Addendum #7

CONSIDER IN YOUR RESPONSE/BID THE FOLLOWING ITEMS OF ADDITION, DELETION OR CLARIFICATION. INDICATE IN THE SPACE PROVIDED ON THE RESPONSE/BID FORM THAT YOU HAVE RECEIVED AND INCLUDED FOR THE REQUIREMENTS OF THIS ADDENDUM. SICKKIDS MAY, IN ITS SOLE DISCRETION ANSWER SIMILAR QUESTIONS FROM VARIOUS RESPONDENTS ONLY ONCE.

RE: QUESTIONS AND ANSWERS, SPECIFICATIONS, DRAWINGS AND DOCUMENTS

AU-02-BW-02 SCALE: 1 : 25

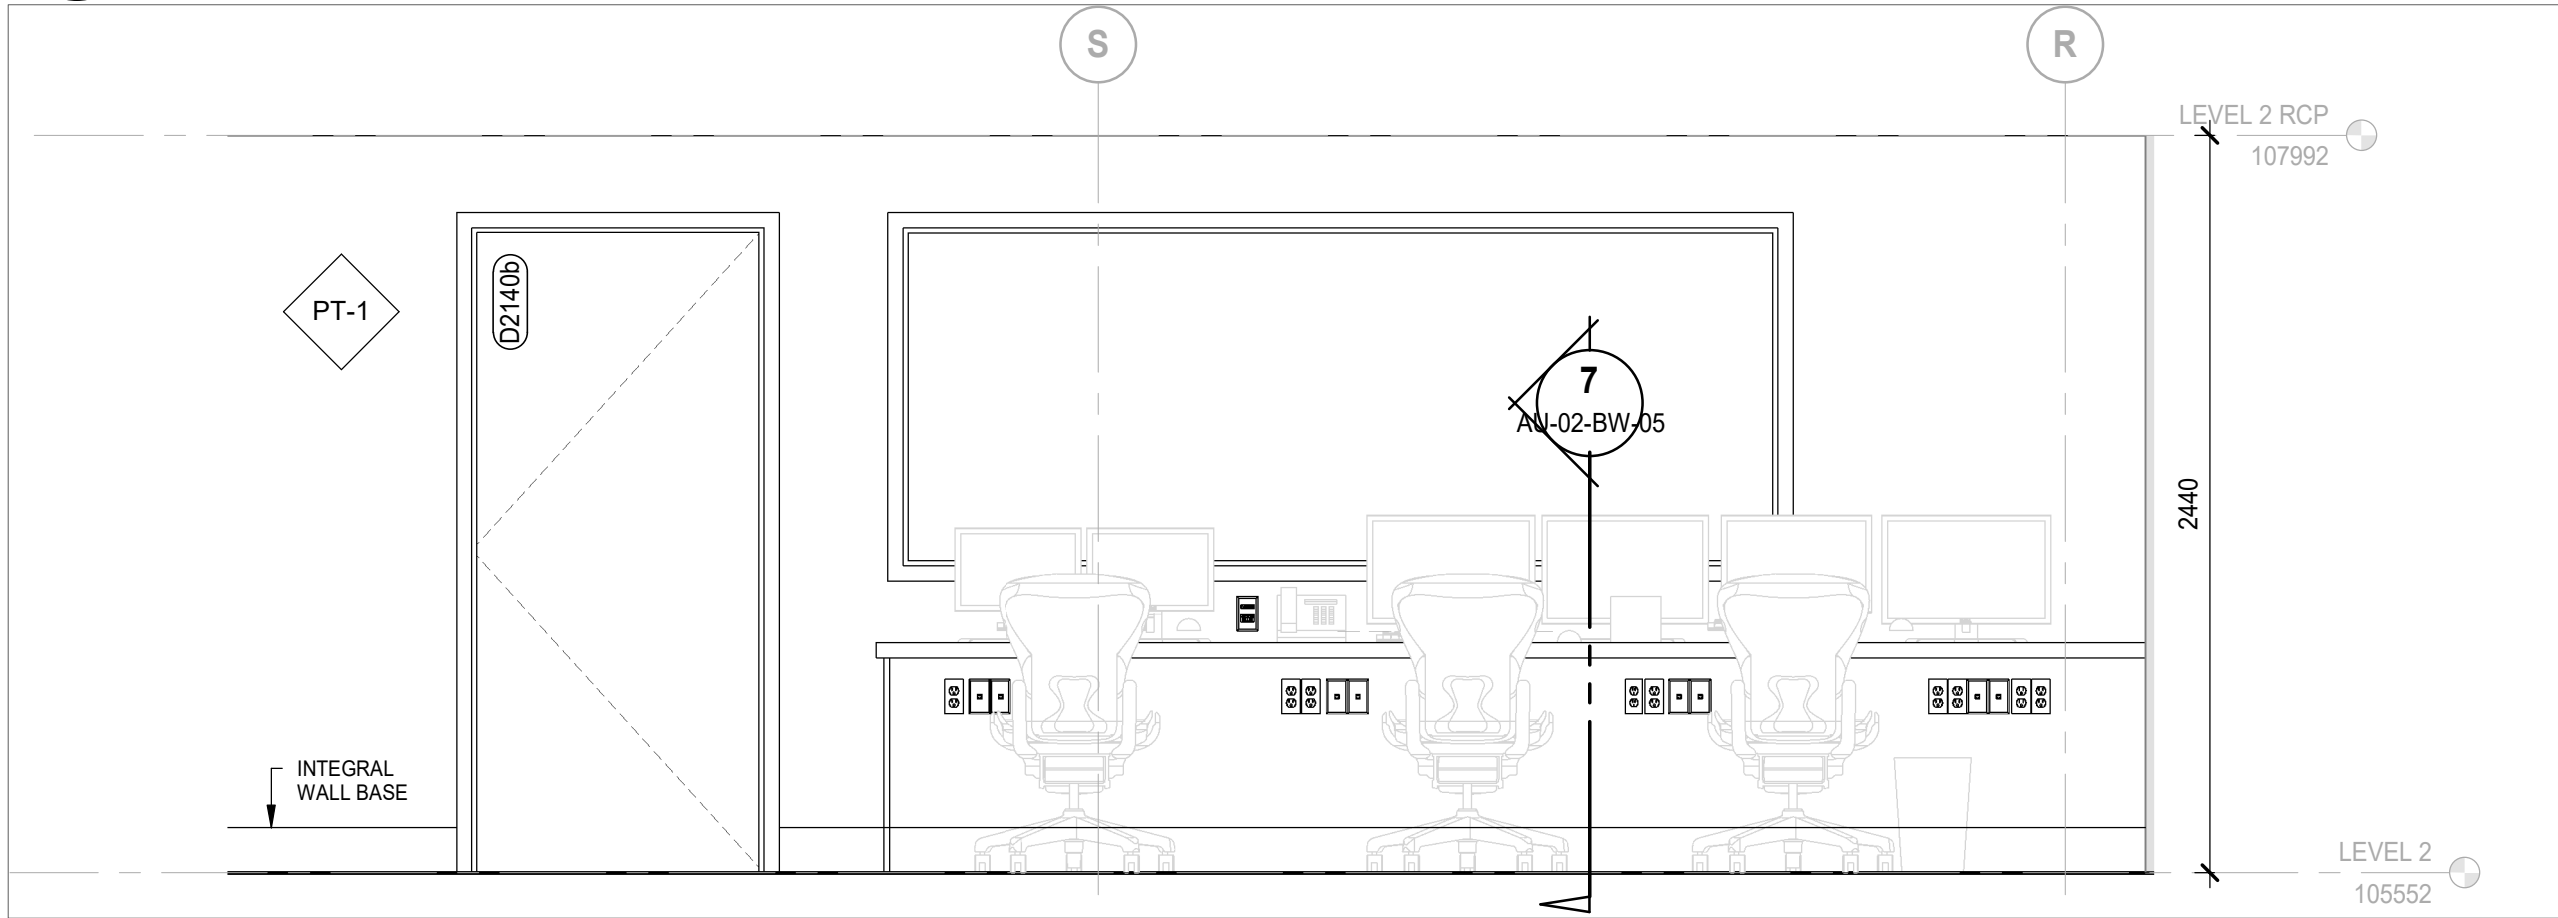
- .5 Drawing AB-02-BW-02 ENLARGED ELEVATIONS
Removed Valve Box and new location of Valve Box
 - .6 Drawing AU-02-BW-05 PLAN, SECTION AND MILLWORK DETAILS
Updated information on Plam.

12 DETAIL - MECH. ROOM INTAKE LOUVER
AB-02-BW-06 SCALE: 1:5

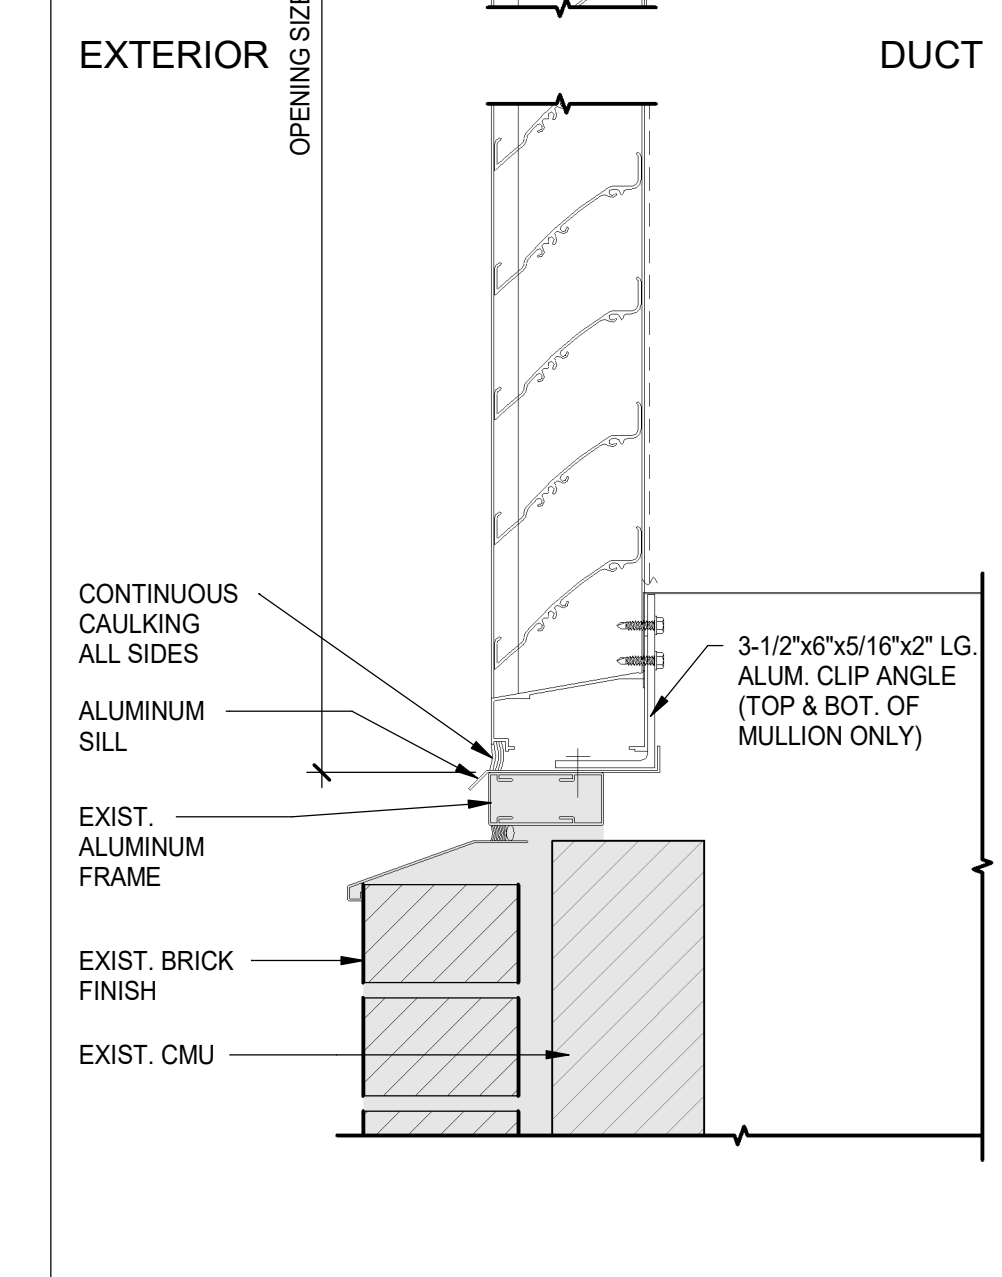
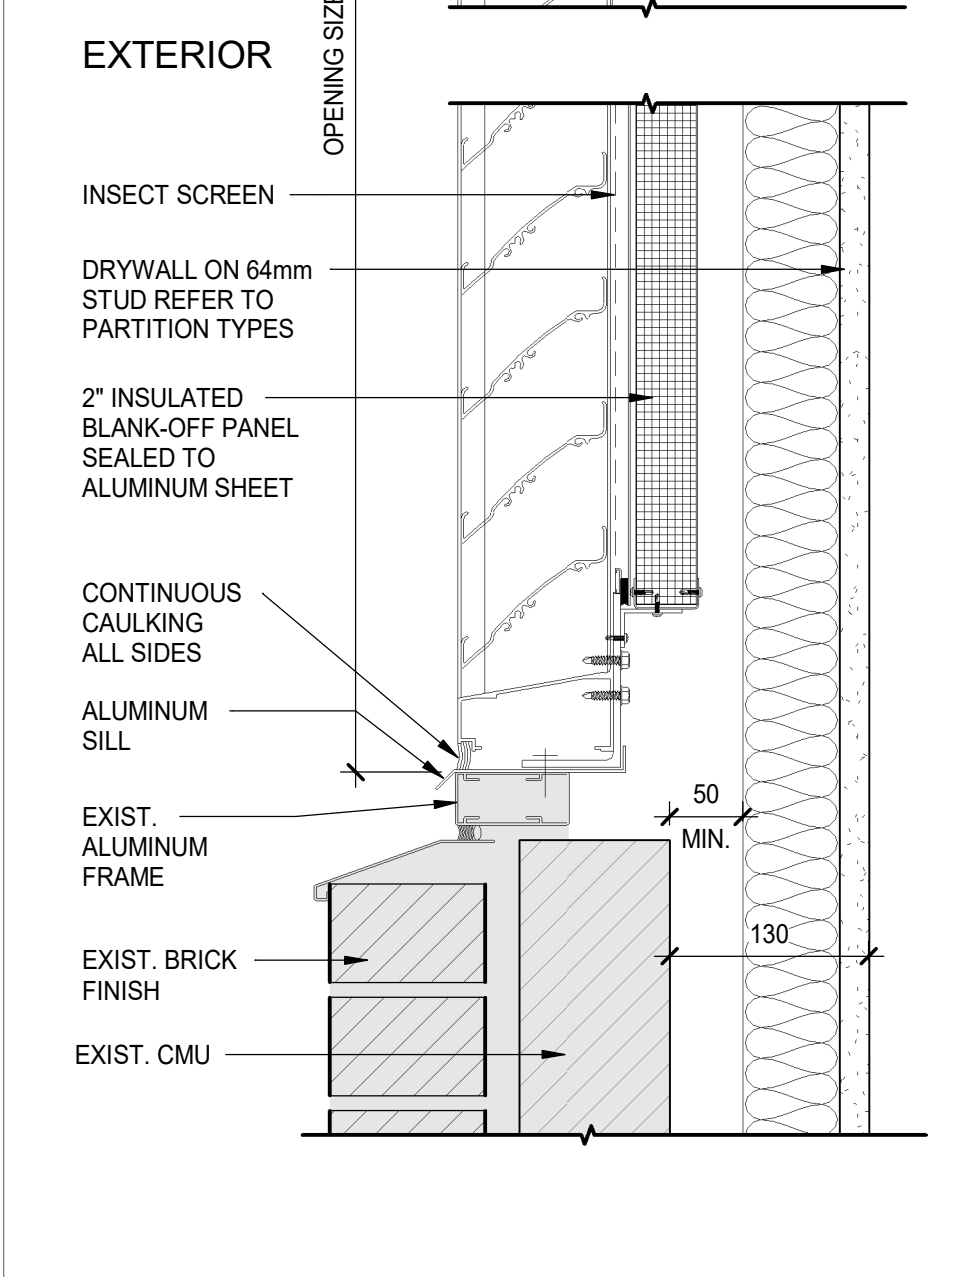
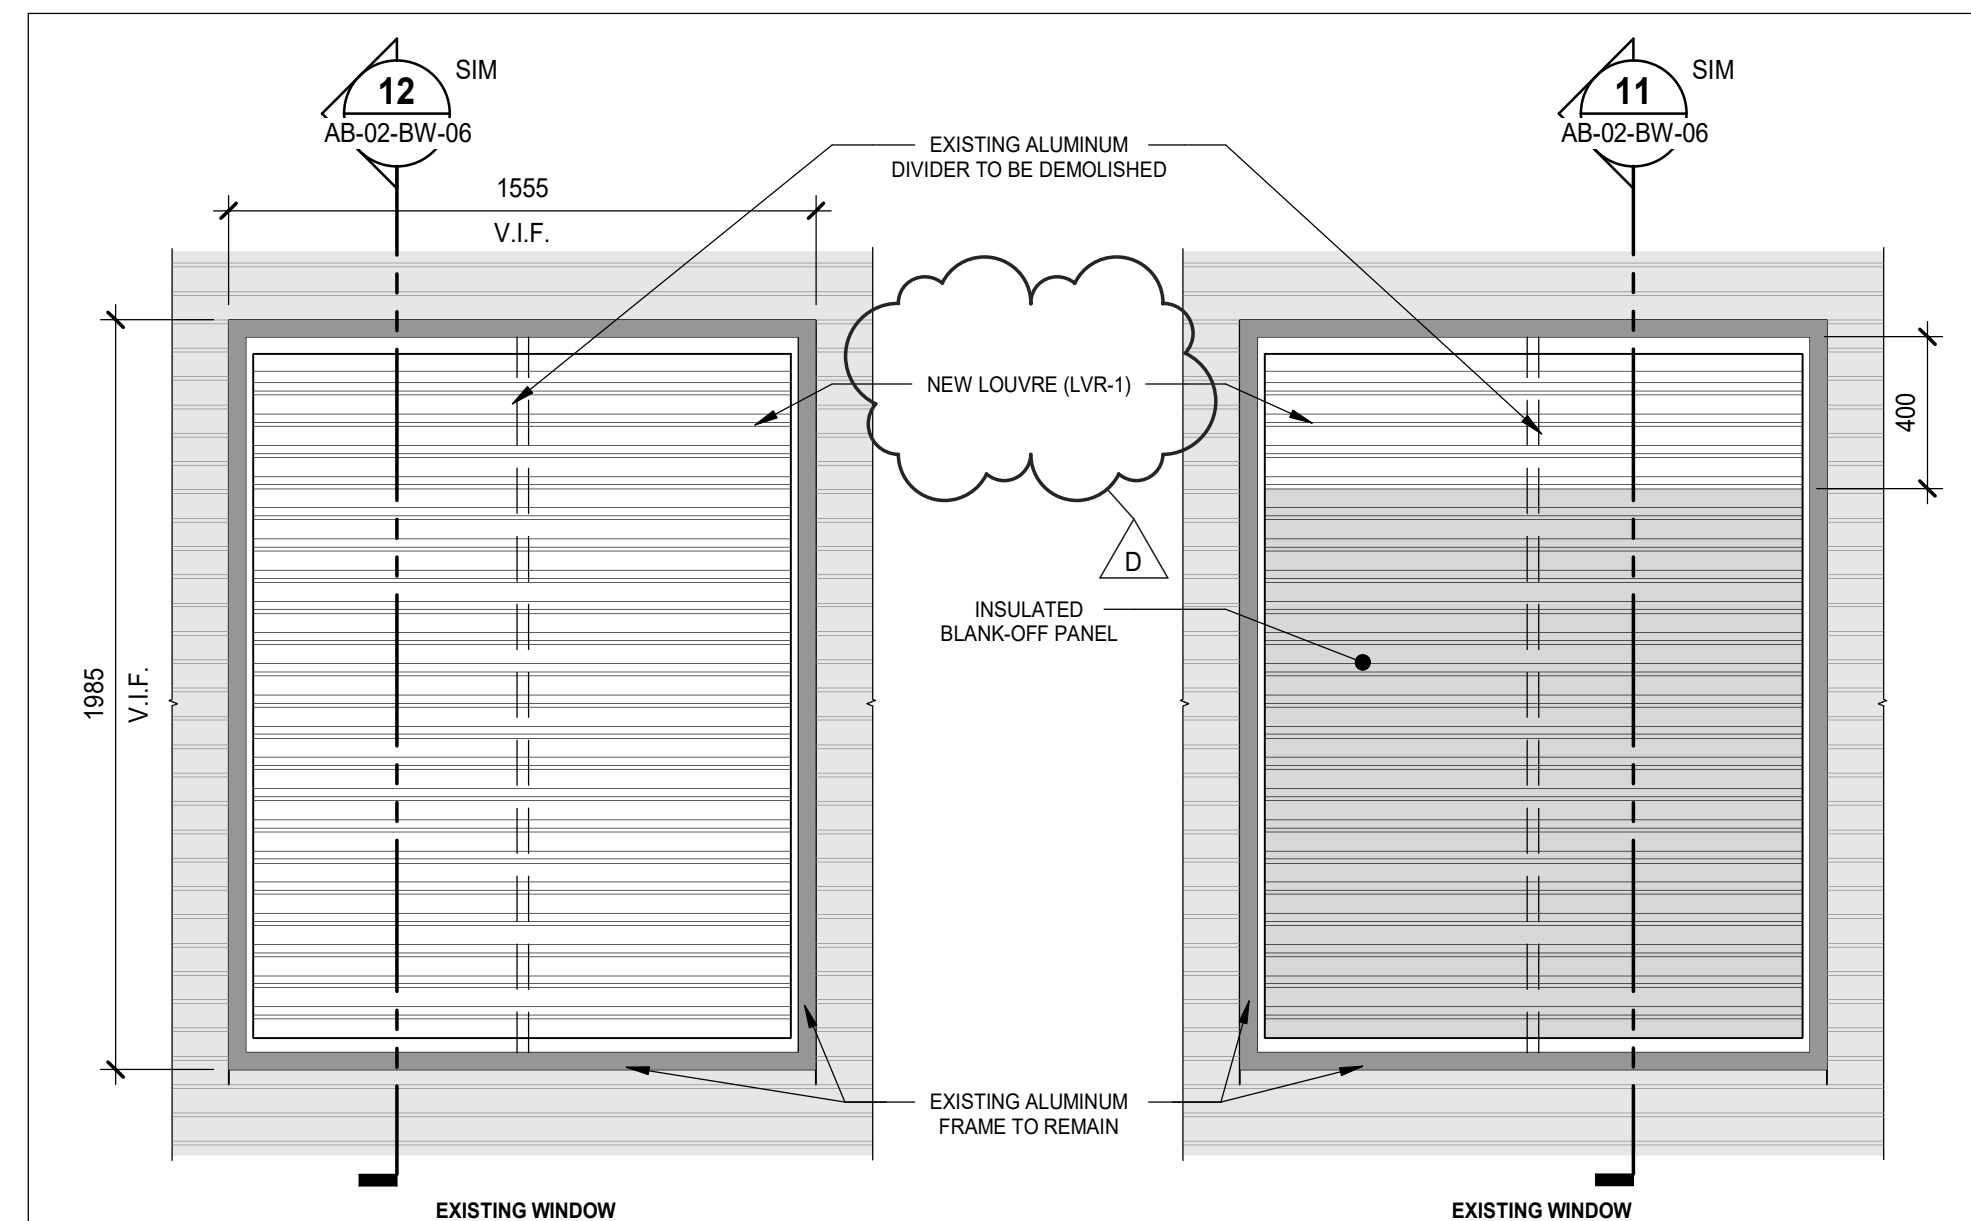
- .7 Drawing AB-02-BW-06 TYPICAL DETAILS
Louvres identified
 - .8 Drawing S02-01 TYPICAL DETAILS
Steel Dowel Clarification
 - .9 Drawing S22-02 LEVEL 2 ENLARGED FLOOR FRAMING PLAN
Various updates on Neoprene pads for the housekeeping pads.

DETAIL 1

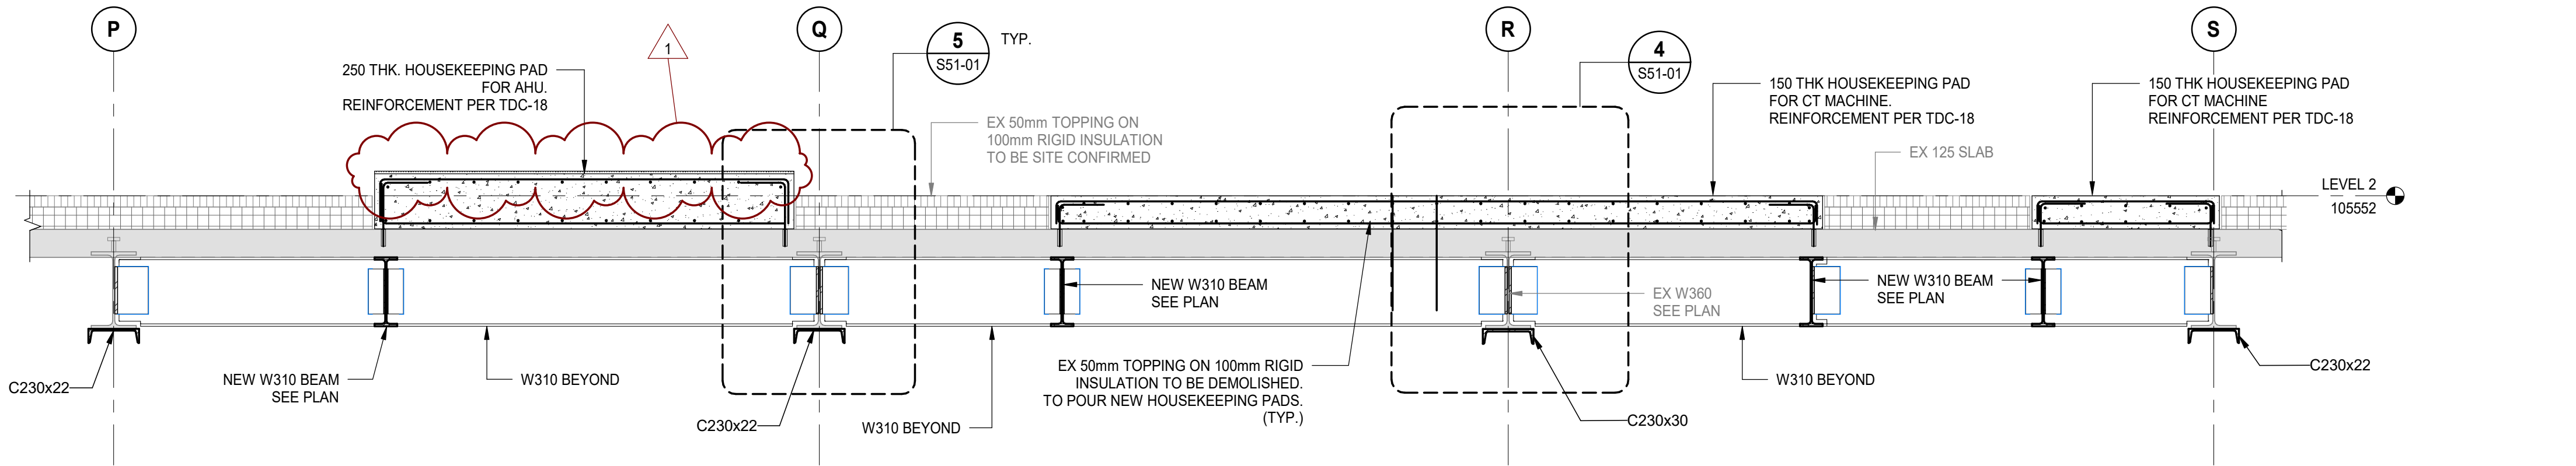
- .10 Drawing S51-01 DETAILS
Update on neoprene pads
